Whole Foods at 2675 Geary Boulevard Project

San Francisco Planning Case No. **2019-004110ENV-02** State Clearinghouse No. 2022060505

MEMORANDUM

Date:	January 10, 2024
Case No.:	2019-004110ENV-02
Project Title:	Whole Foods at 2675 Geary Boulevard Project
То:	Members of the Planning Commission and Interested Parties
From:	Lisa Gibson, Environmental Review Officer
Re:	Attached Responses to Comments on Draft Environmental Impact Report
	for the Whole Foods at 2675 Geary Boulevard Project (Planning Department
	File No. 2019-004110ENV-02)

FIGURE 2-4 SOUTH ELEVATION (REVISED)

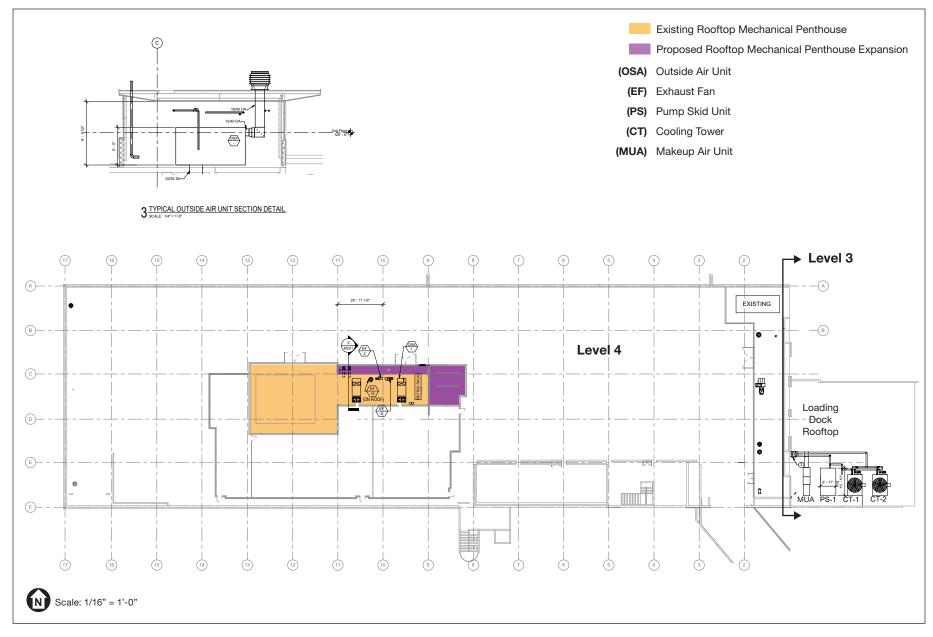
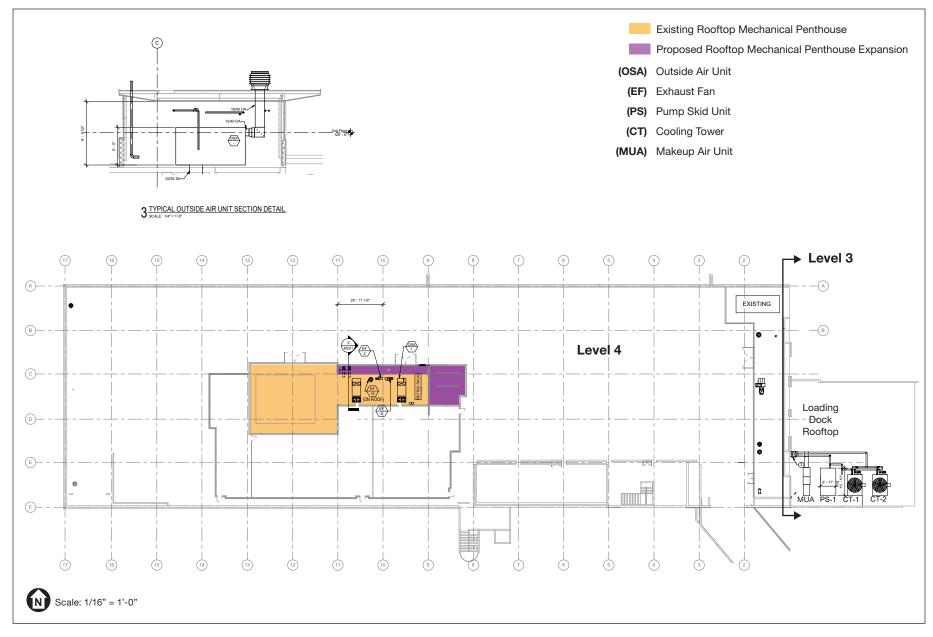
Draft EIR Figure 2-4 and Figure 2-5, draft EIR pp. 2-6 and 2-8, respectively, were revised to show the new cooling tower locations.

The area around the new cooling tower<u>s</u> would be open-air, or without a roof. The cooling tower would extend above the roofline of the existing penthouse (see Figure 2-4, p. 2-6). All other areas of the rooftop mechanical penthouse would be enclosed with a new roof.

FIGURE 4-1 GROCERY STORES WITHIN-1.5 MILES OF THE PROJECT SITE THE MARKET AREA [REVISED]

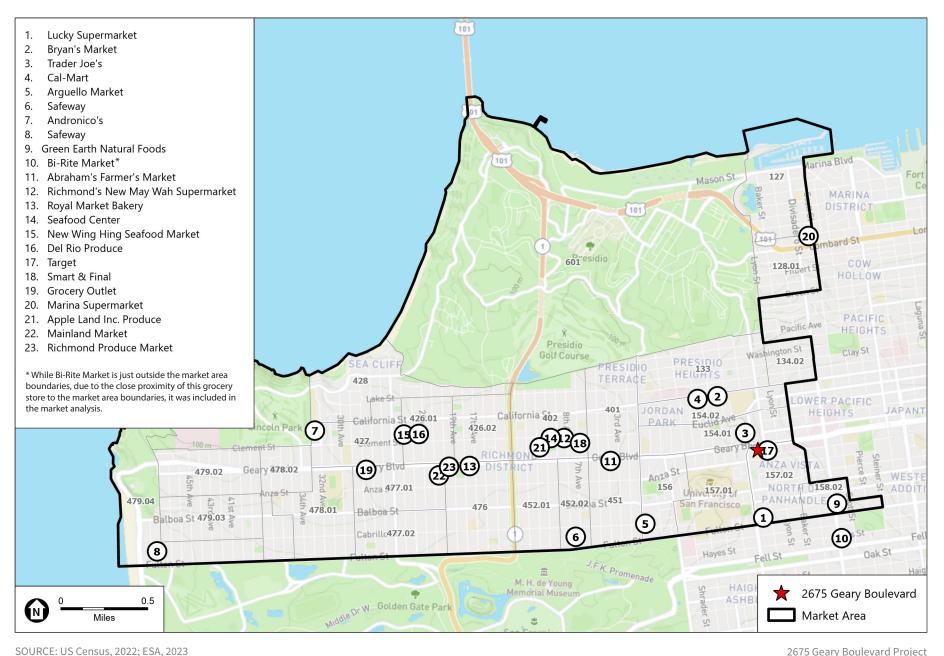
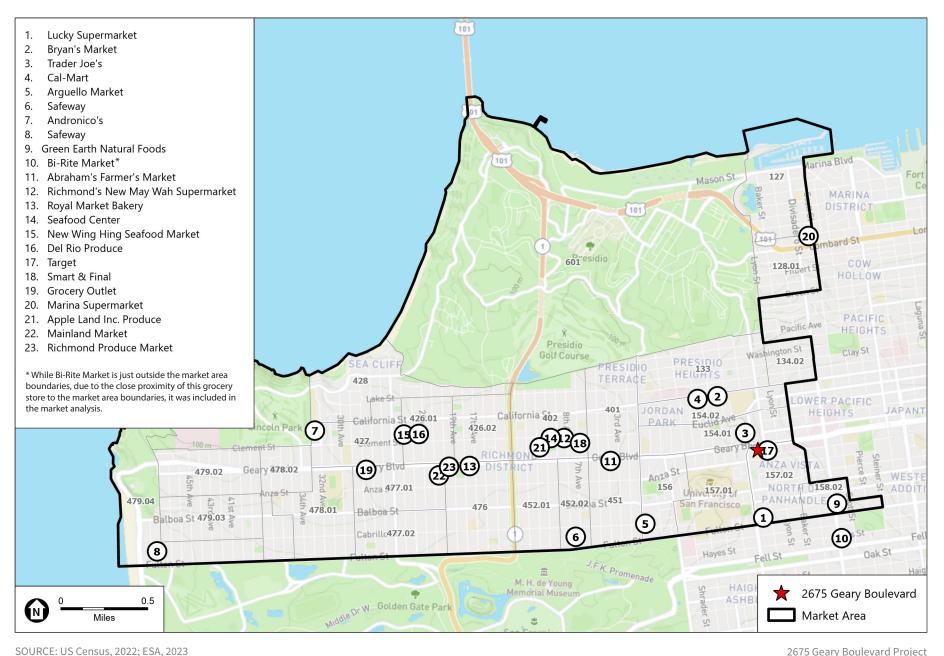
As shown **Table 4-2** and **Figure 4-1**, there are seven <u>23</u> existing grocery stores within <u>1.5 miles of the</u> project site the market area.¹⁴⁷

Figure 4-1, draft EIR p. 4-8, was revised to show the market area that ALH Economics defined for the proposed project:

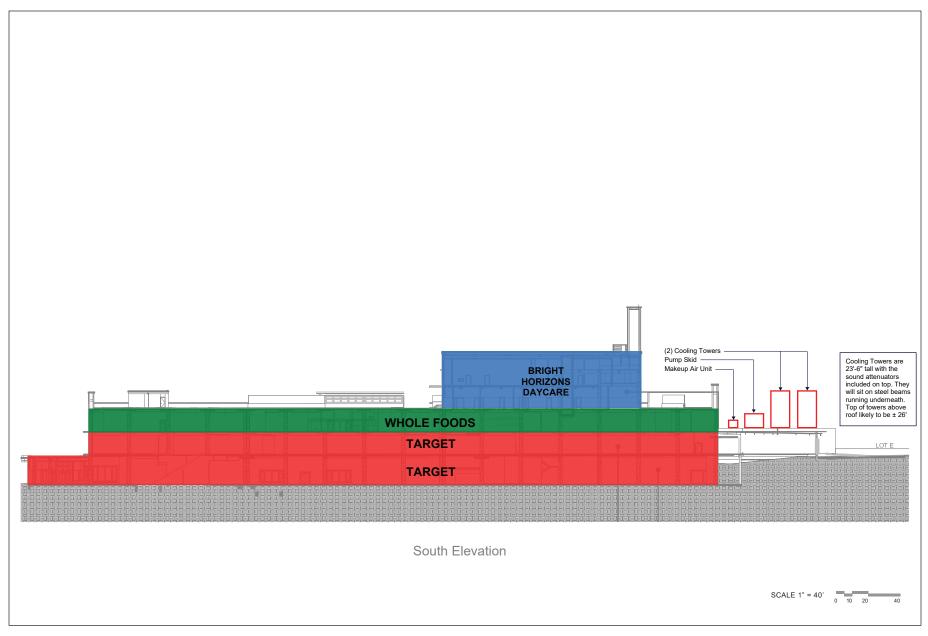
Draft EIR Figure 5-1, p. 5-12, was revised to show the new cooling tower locations.

The only difference between Alternative B and the proposed project is the cooling tower <u>numbers</u> (<u>from one to two</u>), specifications and its location. All other aspects of Alternative B would be similar to the proposed project, including rooftop mechanical penthouse changes for mechanical equipment other than the cooling tower, except this alternative would not require the <u>700_365</u>-square-foot expansion of the rooftop mechanical penthouse.

The cooling tower under this alternative would have a 25-horsepower motor, while the proposed project's cooling towers would <u>each</u> have a <u>30 20</u>-horsepower motor. <u>A lower horsepower motor <u>The</u> single motor under this alternative would result in less electricity demand <u>than the proposed</u> project's two cooling towers, combined.</u>

FIGURE 2-5 PROPOSED ROOFTOP MECHANICAL EQUIPMENT PENTHOUSE CHANGES (REVISED)

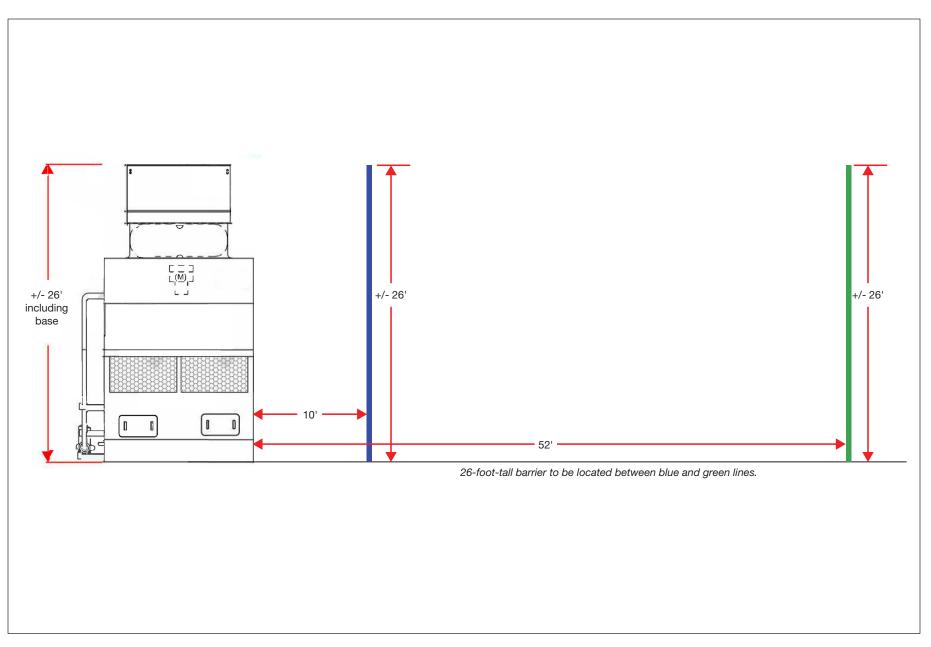
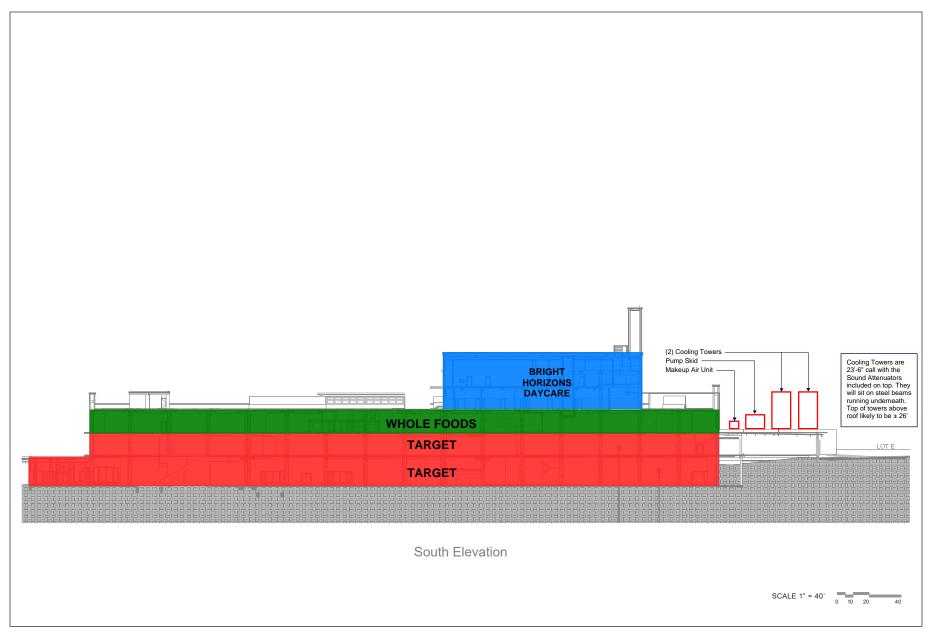
Draft EIR Figure 2-4, p. 2-6, and Figure 2-5, p. 2-8, were revised to show the new cooling tower locations.

skid, and a makeup air unit) on the rooftop of the loading docks (level 3) with associated duct work into the building (see Figure 2-5, p. 2-8).

Figure 4: Cooling Tower Barrier Configuration

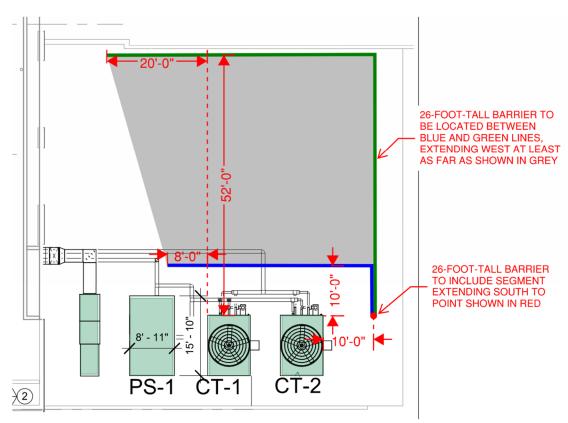
To meet the Police Code Section 2909(b) commercial and industrial property noise limit at the north property plane (i.e., at the Rec-2 location), we recommend providing a barrier on the north and east sides of the cooling towers. To be effective acoustically, the barrier must fully block line-of-sight between the cooling towers and Rec-2 (as well as adjacent segments of the property plane where the noise limit is exceeded). Per the mechanical elevation (see Appendix A), the estimated height of the cooling towers is 26 feet above the roof. The barrier needs to be as tall as the top of the cooling towers, i.e., approximately 26 feet tall, and located as shown in Figure 4.

As shown in **Figure 4**, there is some flexibility in the length of the barrier and the horizontal distance between the barrier and the mechanical equipment. The barrier is to extend at least as far west as the grey-shaded area (the blue and green lines are examples). The east side of the barrier also needs to extend south to the point shown in red which aligns with the northern edge of the cooling towers. The northern barrier could be as close as 10 feet (blue line) or as far as 52 feet (green line) from the cooling towers. As such, the east side barrier could be between 10 and 52 feet long. The barrier needs to be as tall as the top of the cooling towers, approximately 26 feet tall above the roof. Within these constraints, the overall length and design of the wall can vary, depending on where it is constructed.

The barrier should have a weight of at least 3 psf and should be solid without any gaps. A sound absorptive material should be provided at the inside surface of the barrier, facing the cooling towers. Typically, exterior-rated insulation is provided behind a perforated metal face.
